Rezoning Transportation Analysis

Petition Number: 2026-014

Revision Log:

Date	Description
06-25-26	First Review (ME)
07-23-26	Second Review (ME)

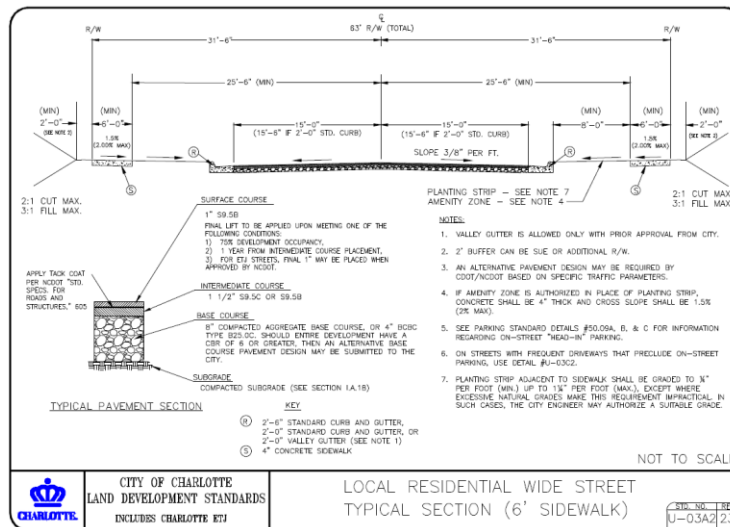
- Dearmon Road:** Location of curb and gutter to be installed to 27-feet from the roadway centerline to accommodate Charlotte Streets Map to match the typical section shown below.

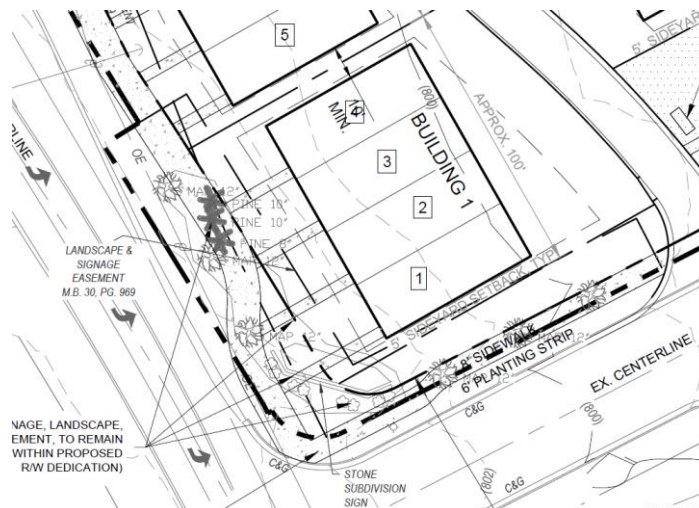
- b. **Browne Road:** Location of curb and gutter to be installed to 30-feet from the roadway centerline to accommodate Charlotte Streets Map to match the typical section shown below. Curb and gutter should be installed such that gutter line is along the edge of travel lane of the existing right turn lane along Browne Road.
